Metropolitan Historic Zoning Commission
Sunnyside in Sevier Park
3000 Granny White Pike
Nashville, Tennessee 37204
Telephone: (615) 862-7970
Fax: (615) 862-7974

STAFF RECOMMENDATION
1300 Fatherland Street
February 19, 2014

Application: New construction—outbuilding
District: Lockeland Springs-East End Neighborhood Conservation Zoning Overlay
Council District: 06
Map and Parcel Number: 08313011100
Applicant: Ken and Sarah Coomer
Project Lead: Melissa Baldock, melissa.baldock@nashville.gov

Site Plan
 1300 Fatherland Street
 in Nashville, Davidson Co., Tennessee
 Metro Map 83-13 Parcel 111 R.O.D.C. January 22, 2014

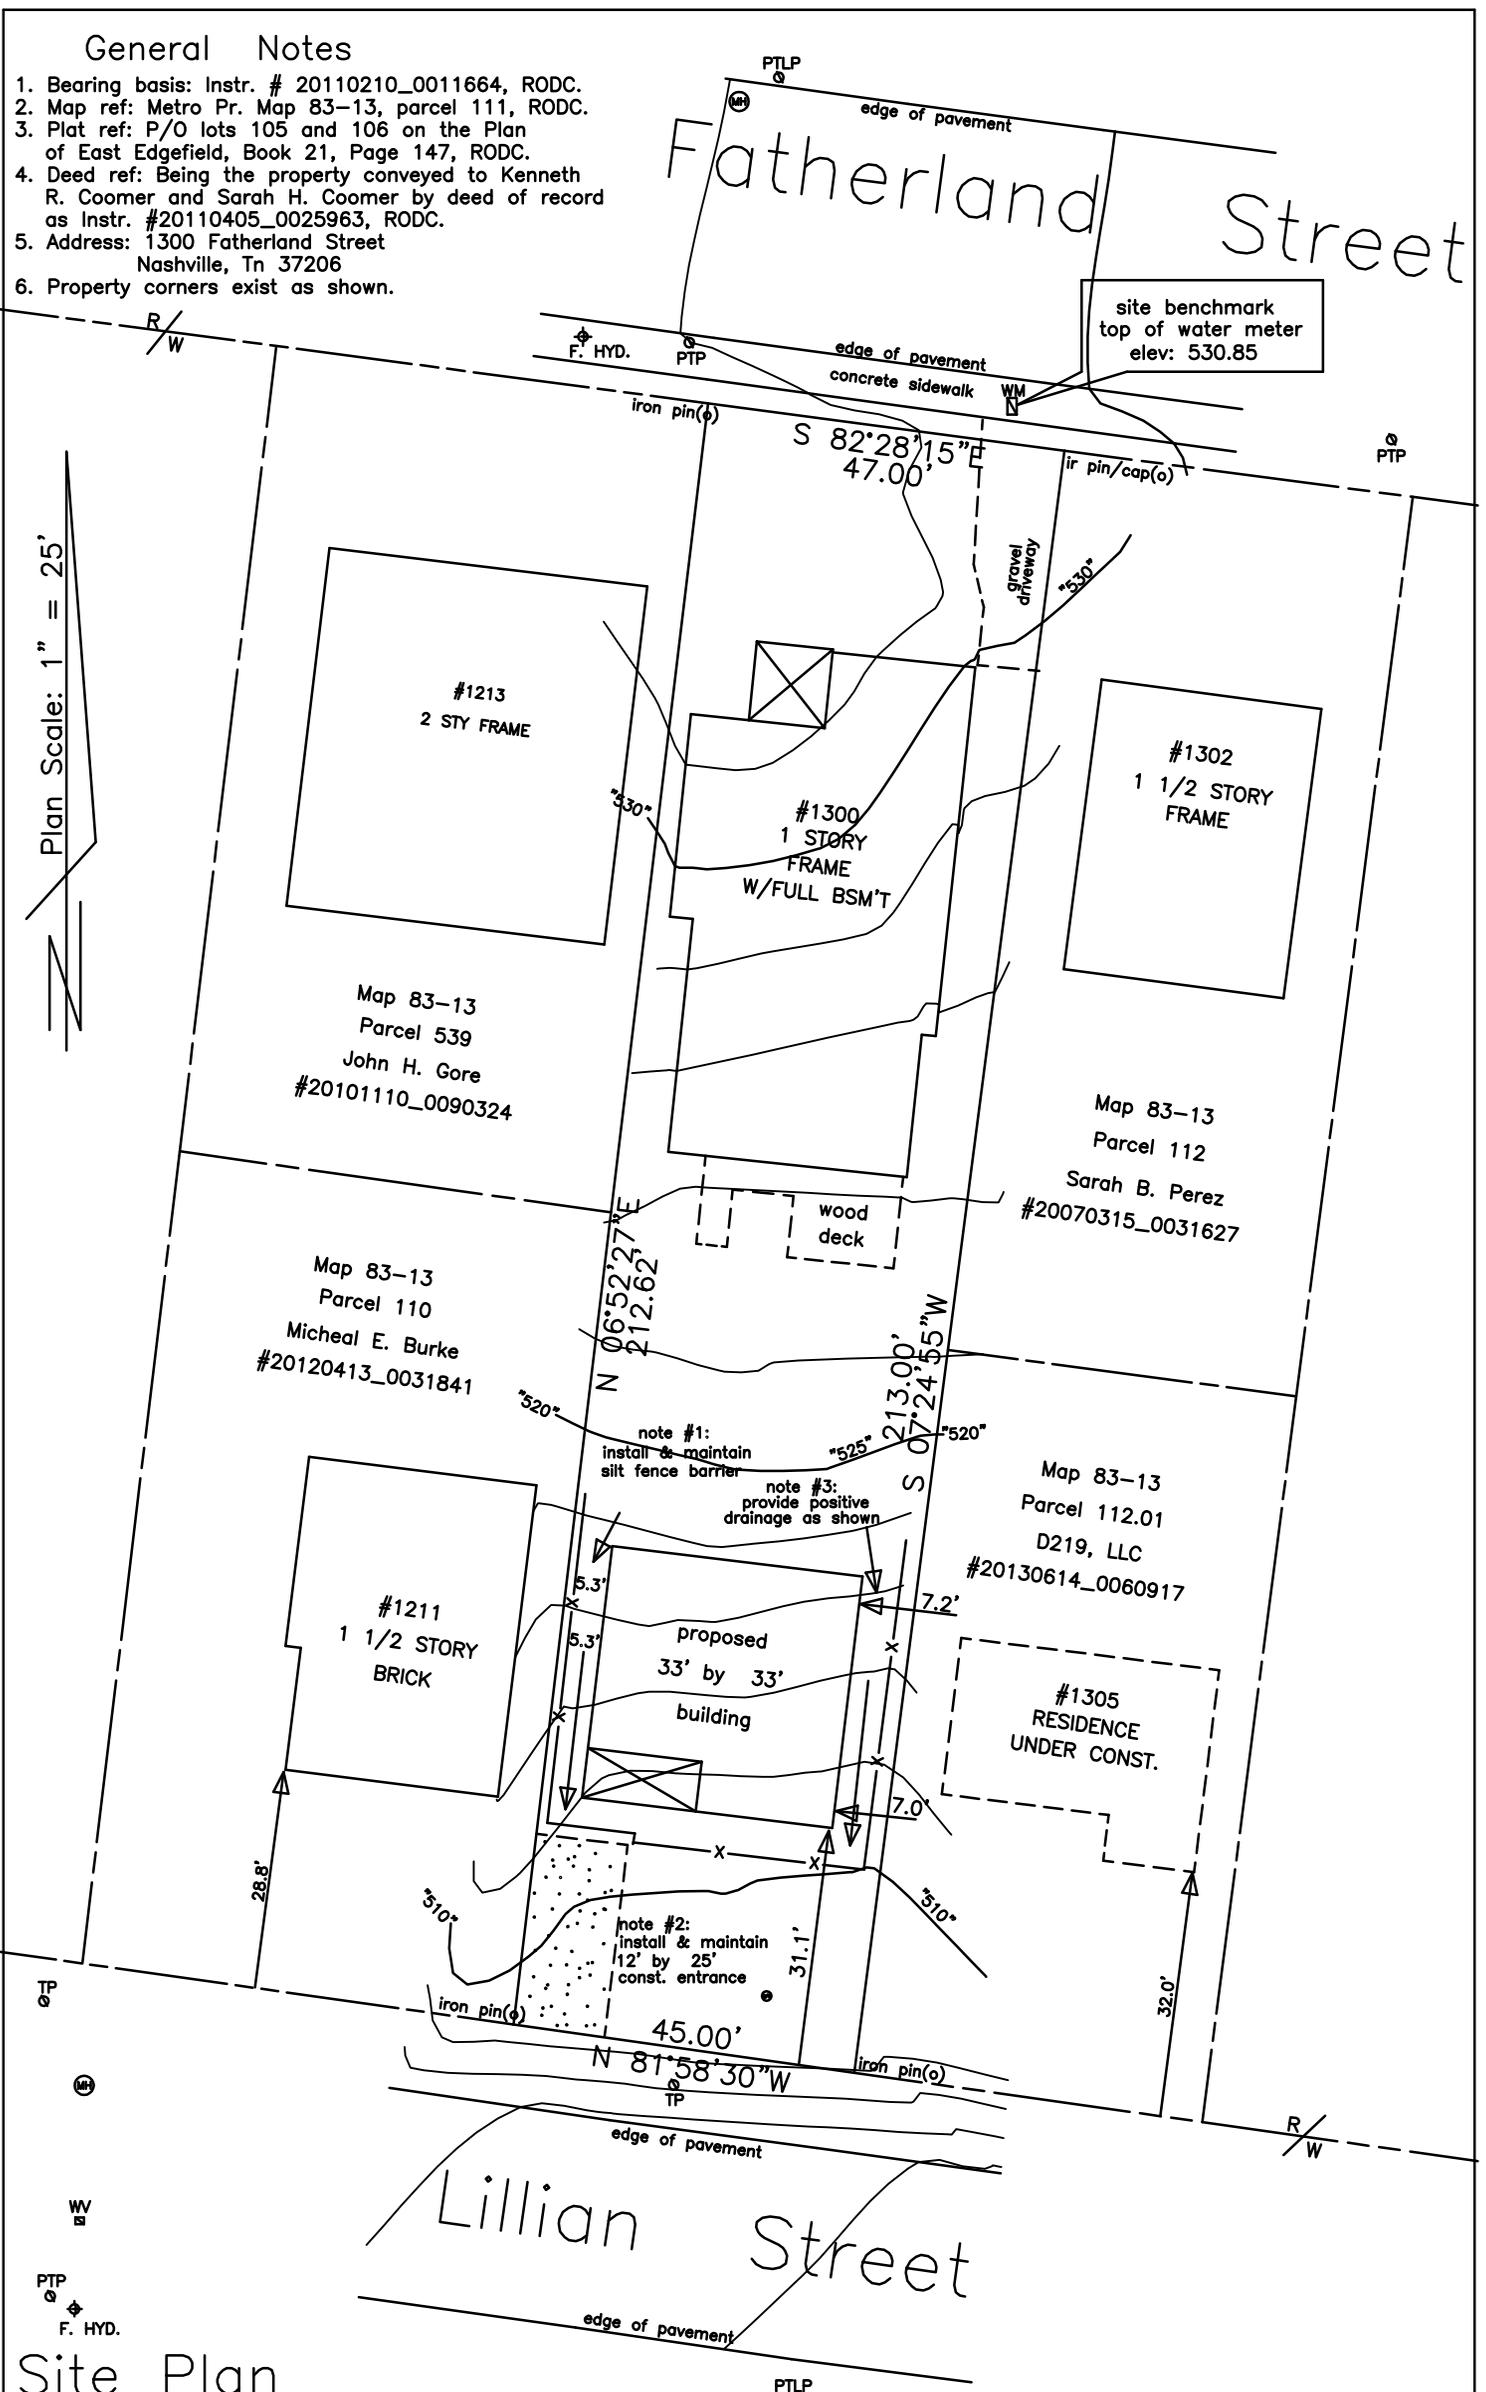
Setback & Rhythm of Spacing: The outbuilding meets all base zoning setbacks for outbuildings larger than seven hundred square feet (700 sq. ft.). It will be approximately seven feet (7') from the east property line; five feet, three inches (5'3") from the west property line; and thirty-one feet (31') from the Lillian Street property line. Its front façade will line up with the front facades of its neighbors at 1211 and 1305 Lillian Street.

Appurtenances & Utilities: No permanent driveway or plan for parking was indicated on the site plan. (Note that the driveway on the site plan is intended for the construction entrance, not for permanent parking for the site.) Staff asks to review and approve the final parking plan for the outbuilding. The location of the HVAC and other utilities was also not noted. Staff asks that the HVAC be located on the rear façade, or on a side façade beyond the midpoint of the house.

1. Staff approve all final materials, including the siding, roof material, foundation material, and windows and doors;
2. The foundation material be continued under the porch;
3. Staff approve the parking plan for the site; and
4. The HVAC be located at the rear of the outbuilding, or on a side façade beyond the midpoint of the structure.

FRONT ELEVATION

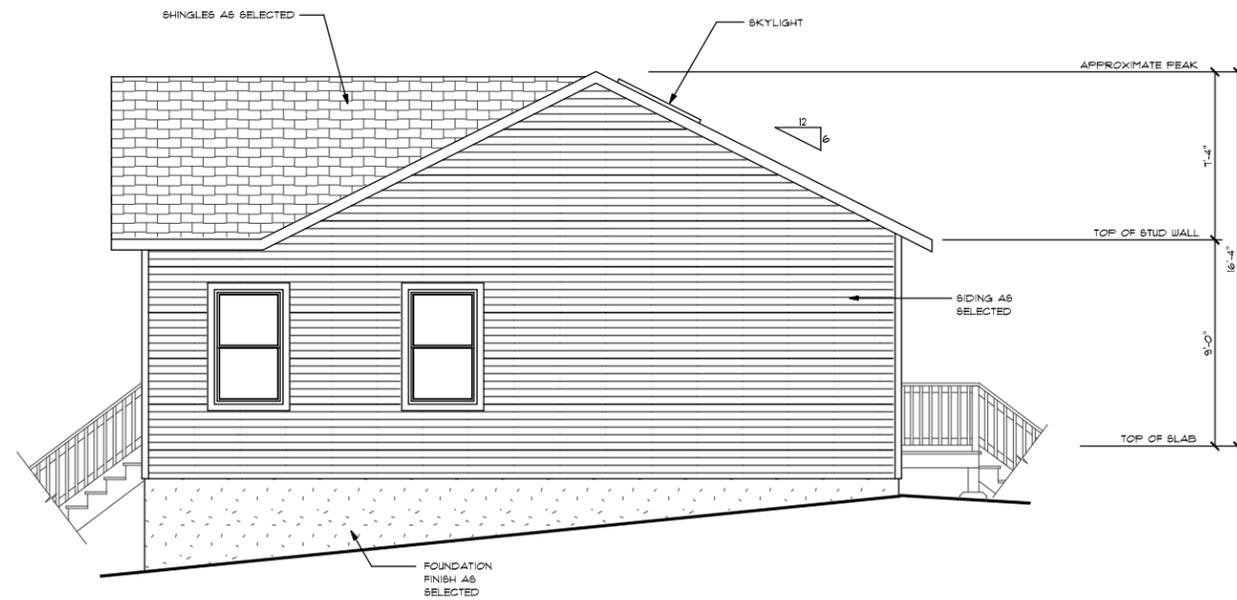
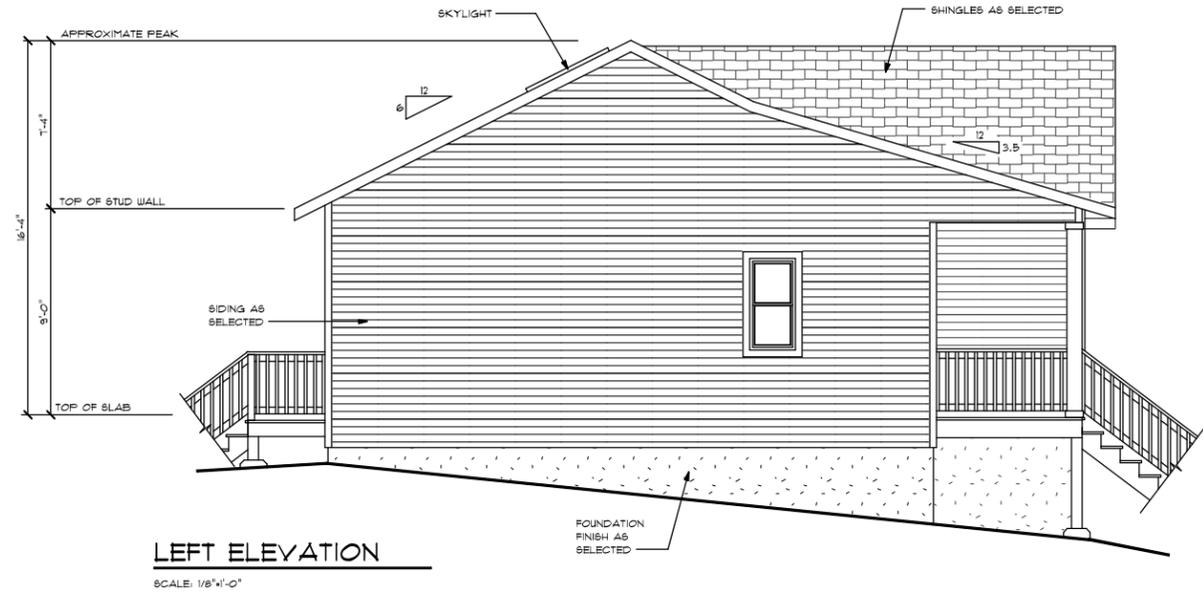
Height & Scale: The proposed outbuilding will be one story tall, with a ridge height of sixteen feet, four inches (16'4") above the foundation line, and an eave height of nine feet (9') above the foundation. Overall, the height of the structure will be lower than the one-and-a-half story infills at 1211 and 1305 Lillian Street, which are twenty-four feet (24') and twenty-six feet (26') above the foundation line, respectively. Staff finds this to be appropriate since the structure is in fact an outbuilding, even if it is designed to address Lillian Street.

The site slopes steeply up from Lillian to Fatherland Street; currently there is about a six to eight foot (6'-8') change in grade from the front of the structure to the back. The foundation is proposed to be four feet (4') tall at the front of the outbuilding, which is taller than what is typically approved. However, the infills at 1211 Lillian and 1305 Lillian have foundations that are approximately four feet (4') tall because of similar grade issues. Staff finds the proposed foundation height to be appropriate in this instance because of the steep slope, and because it will match the foundation heights for the infills approved at 1211 and 1305 Lillian Street.

material. The windows should be wood or aluminum clad, and the front door should be wood. The foundation should be split face concrete block, stone, or brick. The drawings show that the porch is supported by posts instead of a foundation. Staff asks that the foundation material be continued under the porch. Staff asks that a condition of approval be that staff review and approve all final materials to ensure that they comply with section II.B.4 of the design guidelines.

Roof form: The outbuilding will have a cross gable roof form. The front gable will have a pitch of 8.5/12, while the side gable will have a slope of 6/12. Staff finds that this roof form is compatible with other primary structures in along Lillian Street and Fatherland Street. The project therefore meets section II.B.5. and II.B.8. of the *Lockeland Springs-East End Neighborhood Conservation Zoning Overlay: Handbook and Design Guidelines*.

Proportion and Rhythm of Openings: Most of the windows on the outbuilding are twice as tall as they are wide, meeting the historic proportion of window openings. On the front façade, behind the porch, is a window that does not meet the historic proportion of window openings. Staff finds this three foot by three foot (3' X 3') window opening to be appropriate in this instance because the structure is an outbuilding, and generally outbuildings had minimal and more utilitarian window openings. In addition, the constraints of the floor plan make a larger window opening problematic. On the side elevations, there are expanses of eighteen feet (18') without a window or door opening. Again, because this is an outbuilding and not infill construction, staff finds these expanses to be appropriate. Staff finds the project's proportion and rhythm of openings to meet Section II.B.7. and II.B.8. of the *Lockeland Springs-East End Neighborhood Conservation Zoning Overlay: Handbook and Design Guidelines*.
